Textown Limited (9704)

Ornate Knit Garments Industries Ltd (9701)

Dewan Idris Road, Bara Rangamatia, Ashulia, Savar, Dhaka, Bangladesh.

11.MARCH.2014

Escape Staircase is in Poor Condition

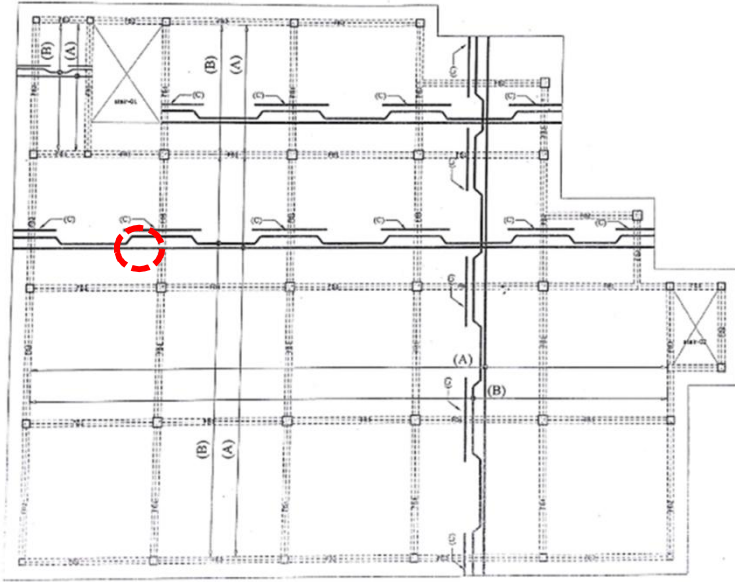
The staircase at the side of Building 03 is meant to be a fire escape staircase. This means that there is a potential for crowds of people to use this stair in the event of emergency. However, the stair was built from very small steel members, and had not been properly galvanised, and therefore had rusted very badly. The structural stability of this staircase is questionable, and appears unsafe for its intended purpose

- Consider the renewal of this staircase, using suitable corrosion-resistant materials, and of a design suitable for emergency and panic loading.
